**PR/0934/22**

## Record of Executive Business and Chief Executive's Order

**Reg. Reference:** SD21A/0287      **Application Date:** 20-Oct-2021  
**Submission Type:** Additional      **Registration Date:** 27-Jun-2022  
Information

**Location:** Kiltipper Woods Care Centre, Kiltipper Road,  
Bohernabreena, Dublin 24, D24A248

Land Transfer Map submitted as part of Additional Information Response.

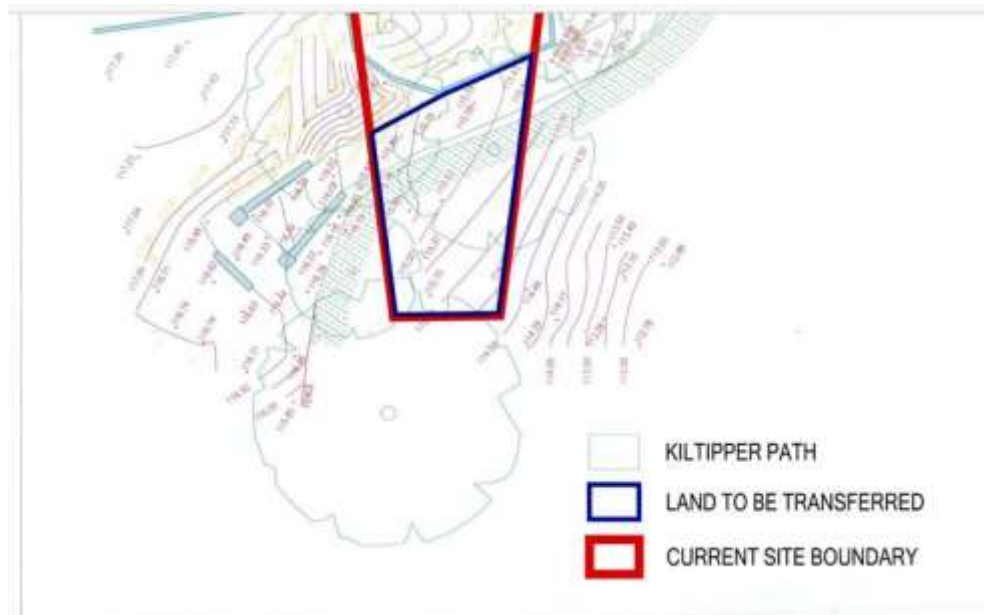
*The transfer of land as required under Item 2 of the Request for Further Information shall take place prior to the commencement of the permitted development. In order to proceed with the transfer of title of the open space lands to SDCC as agreed with the Public Realm Section and as outlined within the submitted documentation, the developer shall submit the following information for the written approval of the Public Realm Section:*

It is considered appropriate to attach the above **conditions** in the event of a grant of permission. It is noted that it was confirmed by the Parks Department and the applicant that the land parcel subject to land transfer measures an area of 99.6s.m. (0.00996Ha). The Planning Authority consider that the pedestrian gate should be included.

The transfer of land (c99.6sq.m./0.00996Ha) to South Dublin County Council as detailed in the response to Item 2 of the Request for Further Information shall commence prior to the commencement of the proposed development and shall be completed prior to the occupation of the proposed development.

An extract taken from the SDCC Roads report states the following:

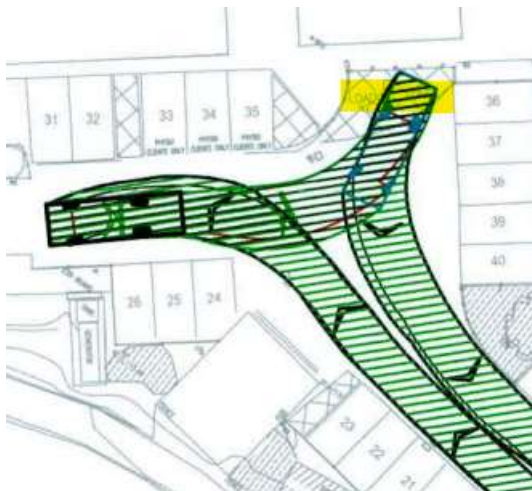
*3 (b) A 1.5 m advisory cycle lane marking needs to be provided along the access road into the development. The drawing provided is not clear in this regard. Detailed section drawing is required to show kerb lines, footpath and advisory cycle lane markings. Roads require that one course of 10mm SMA is laid at 40mm depth and 14mm AC base course material shall be laid on any carriageway/footpath shared surfaces.*

*3 (c) A swept path analysis drawing has been submitted by the applicant showing refuse truck turning movements.*

- 1. Prior to commencement, the applicant to submit a revised drawing showing minimum 10% of carpark spaces equipped with EV function. (4no. EV Spaces). This is to be agreed in writing with the planning department.*

- 2. Prior to commencement, the applicant shall submit a revised drawing showing the removal of car parking spaces no. 55 to no. 59 and replaced with a 2.0m wide footpath at this location.*

- 3. Prior to commencement, the applicant to submit a revised access road plan drawing showing a 1.5m wide advisory cycle lane. A section drawing should also be included showing dimensions of the advisory cycle lane, the overall carriageway width and footpath width at three locations along the access road into the development.*
